Re: Florida Power & Light Company
Proposed Turkey Point Units 6 and 7
Docket Nos. 52-040 and 52-041
Voluntary Revised Response to NRC Request for Additional Information Letter
No. 040 (eRAI 6006) – Standard Review Plan Section 02.05.04 –
Stability of Subsurface Materials and Foundations

NRC RAI Letter No. PTN-RAI-LTR-040

NRC RAI Number: 02.05.04-16 (eRAI 6006)

Figure 1 Vertical RQD Variation

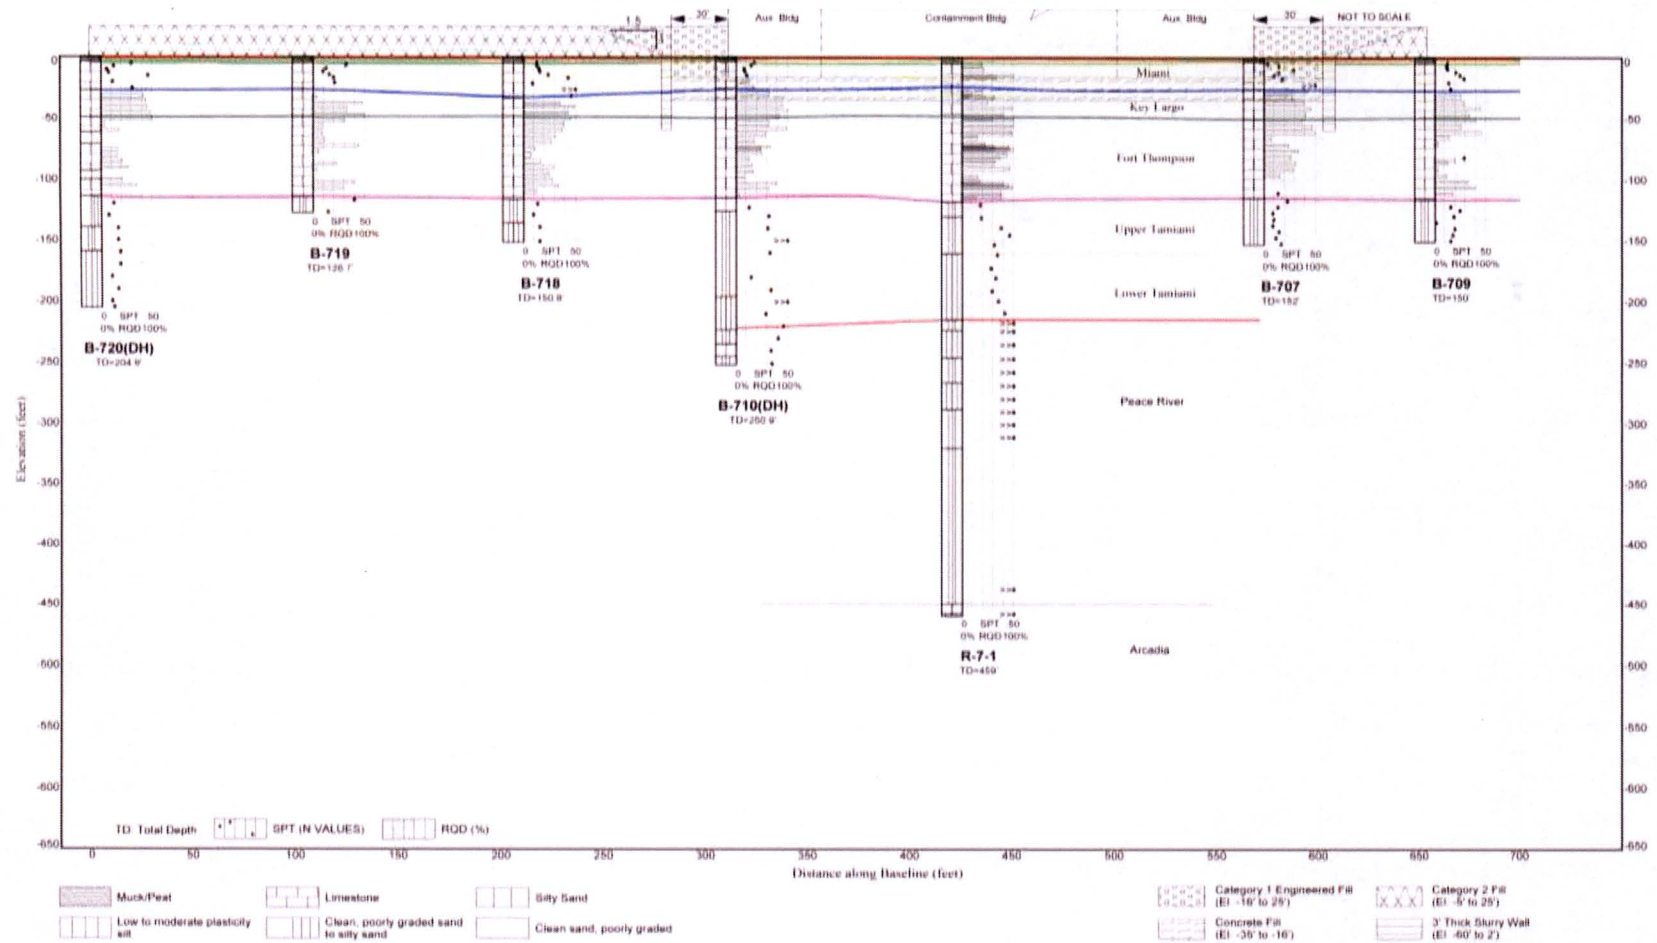
Section 2.5.4.7.3.3 "Shear modulus and Damping for Rock", indicates that the damping for rock is taken as 1%. The damping shown in Figure 2.5.2-249, which describes the soil properties used to develop the GMRS, indicates that a damping value of 0.5% was used in the analyses. In accordance with NUREG-0800, Standard Review Plan, Chapter 2.5.4, "Stability of Subsurface Materials and Foundations," please provide clarification as to the actual level of damping used in the analyses and provide a basis for its selection considering the large variability in RQD shown in Figure 2.5.4-215.

The variability in RQD within each stratum is generally random in nature and does not have directional trends (e.g., high RQD at the top of the stratum and low RQD at the bottom), thus, the strata are not sub-divided within each formation. Figure 1 shows vertical RQD variability in the boreholes of cross-section A-A (see Figure 2). The lateral variability for the Key Largo and Fort Thompson formations is presented in Figures 3 and 4. The natural variability, which is evident in Figures 1, 3 and 4, is addressed through a randomization process for site response analysis as described in FSAR Subsection 2.5.2.5.2.
